Subject: Evaluation of Candidate MgO Materials for use as Backfill at WIPP

subject: Evaluation of Candidate MgO Materials for use as Backfill at WIPP

1. ECP # _____	2. REC'D DATE _____	3. SYSTEM # <u>WH02</u>	
4. TITLE: <u>Revise Specification for Prepackaged MgO Backfill</u>			
5. CLASS: <input checked="" type="checkbox"/> 1 <input type="checkbox"/> 2	6. COSTS: FY: <u>00</u> \$ <u>-0-</u>	7. WORK ORDER #: <u>N/A</u>

Figure 3.1

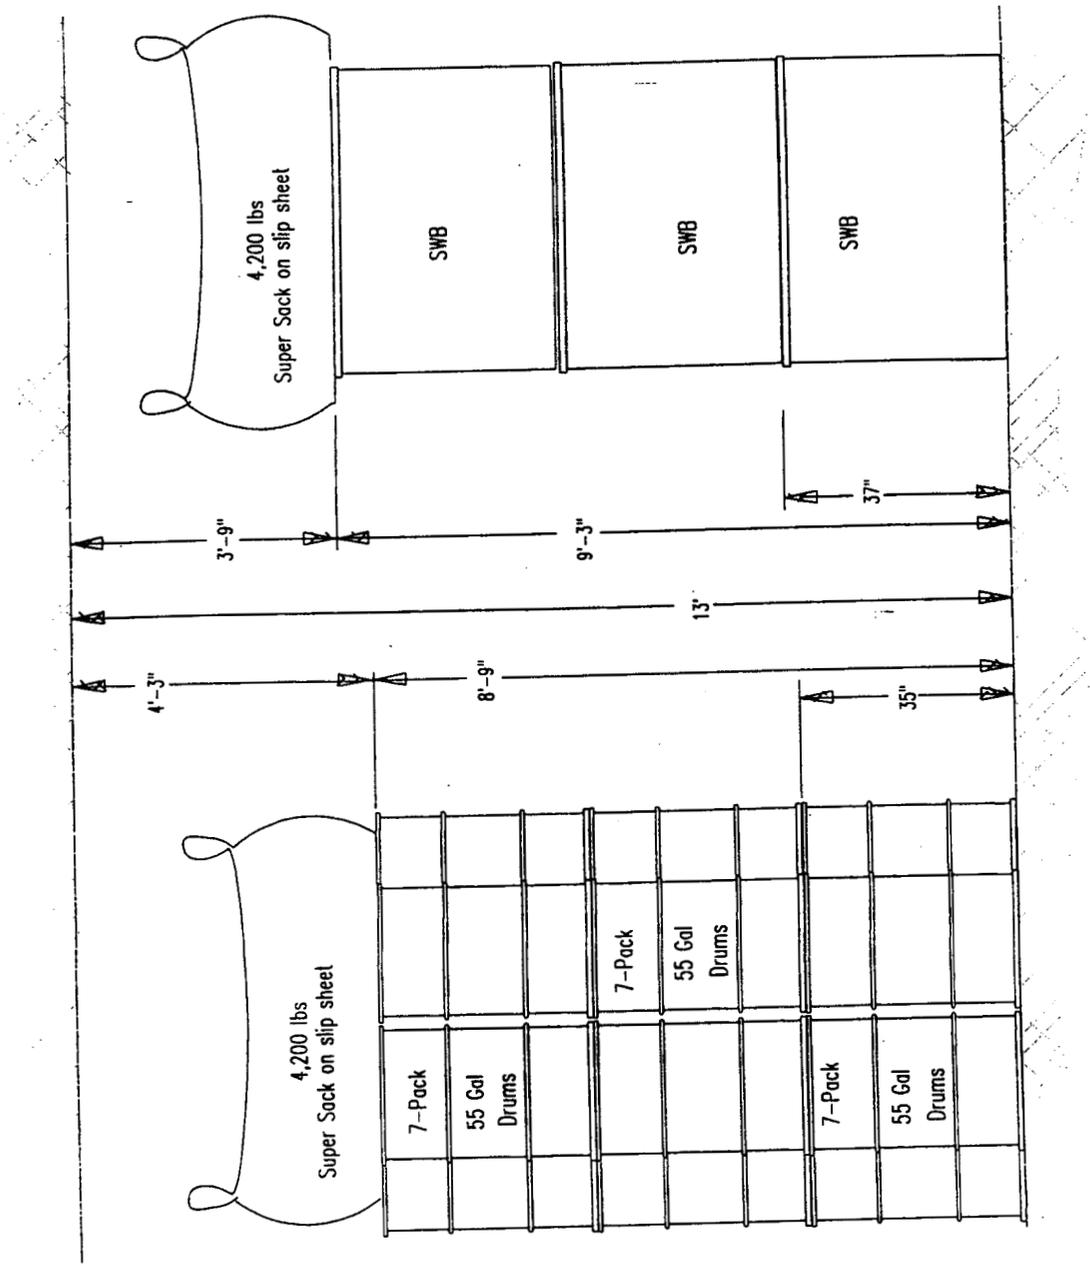
3.2.1 Supplier filled super sacks will be handled during transportation to the WIPP, at receipt and during material handling operations on support sheets. Refer to Figure 3.1 for the emplaced position of the super sack.

3.2.3 A filled "Super Sack" and its support sheet will be placed on top of one of four waste containers; Standard Waste Box (SWB), 7-pack of 55 gallon drums (Figure 3.3), Ten Drum OverPack (TDOP), or a 4-pack of 85 gallon overpack drums (Figure 3.4). The filled super sack must be able to retain its contents for a period of two years after emplacement without rupturing from its own weight.

3.4.1 The supplier shall provide backfill containers which comply with the requirements for super sacks as outlined in Sections 3.3.2 above. The super sack shall be filled with ~~4,100~~ 4,200 ± 50 pounds of backfill material as specified in Section 3.3.1.5 above.
